SUBJECT: REQUEST FOR ADDITIONAL INFORMATION LETTER NO. 09  
(SRP SECTIONS: 02.05.01 – BASIC GEOLOGIC AND SEISMIC  
INFORMATION, 02.05.03–SURFACE FAULTING) RELATED TO THE  
VICTORIA COUNTY STATION EARLY SITE PERMIT APPLICATION

Request for Additional Information No. 5678 Revision 0

Victoria County Station ESP  
Exelon Texas  
Docket No. 52-042  
SRP Section: 02.05.01 - Basic Geologic and Seismic Information  
Application Section: 2.5.1

Victoria County Station ESP  
Exelon Texas  
Docket No. 52-042  
SRP Section: 02.05.03 - Surface Faulting  
Application Section: 2.5.3

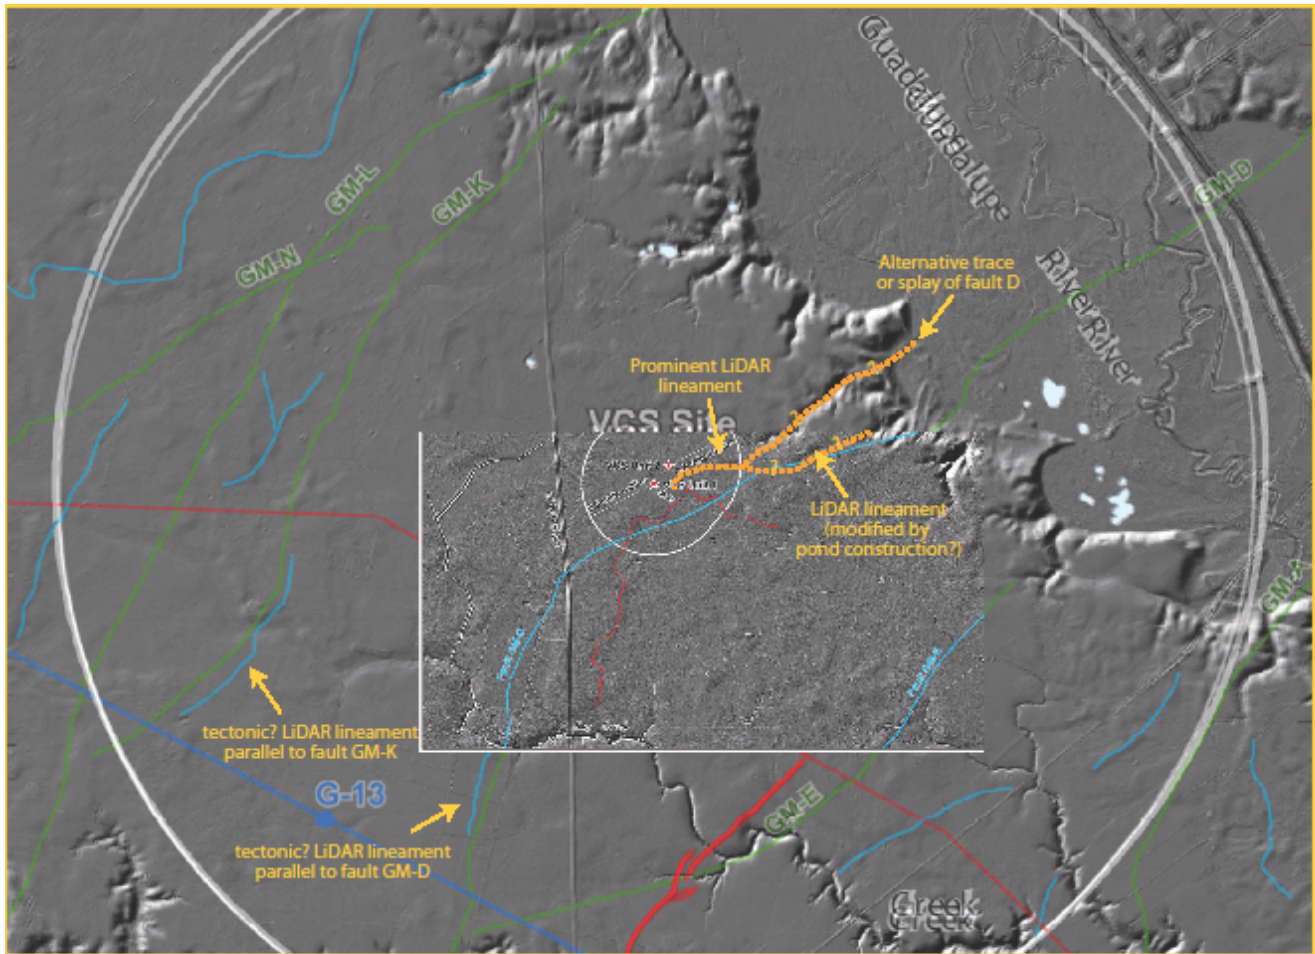
SSAR Section 2.5.1.2.4.2.2 describes criteria used to classify lineaments from airphoto and LiDAR data as related either to growth faulting or to non-tectonic processes. Many lineaments interpreted by you to be of fluvial origin (Figs. 2.5.1-37, 41, 42) lie near and on-trend with surface projections of faults K and D (**see attached Figure 1**). One lineament parallels fault K turn-for-turn for more than 3 km, yet is interpreted as fluvial in origin. Many lineaments interpreted as fluvial scarps trend nearly perpendicular to the regional slope and flow direction, and appear to be southeast-facing, consistent with the slip direction of growth faulting in the region. In support of 10 CFR 100.23 please discuss the alternative interpretation that many of these lineaments are surface manifestations of active growth faulting rather than fluvial processes, and the implications for site safety.

In SSAR Section 2.5.1.2.4.2.3 you describe the identification of growth faults from aerial photographs and LiDAR topography shaded-relief maps. The staff observes that both air-photo and LiDAR data (Fig. 2.5.1-37, -38, -42) suggest that growth fault D (or a splay thereof) may extend 1-2 km northeastward instead of turning sharply to the southeast near the power block (**see attached Figure 1**). This may be a more linear trace for Growth fault D that would correspond to the more typical trend of other GeoMap faults in the vicinity. In addition, cross-sections in Figure 2.5.4-15, between boreholes B-04 and B-2316 and Figure 2.5.4-16, between boreholes B-2354 and B-2322, show small (~1 m) steps in topography and 1-3 m apparent offsets of several subsurface units that may be evidence of a fault trending in this direction.

In accordance with 10 CFR 100.23 (d), explain why this potential trend was not considered part of fault D. Please provide an evaluation of the borehole data, cited above, with regard to a possible shallow fault trending northeast rather than southeast. Please discuss the safety implications of this possible fault splay, which would be closer to the power block.
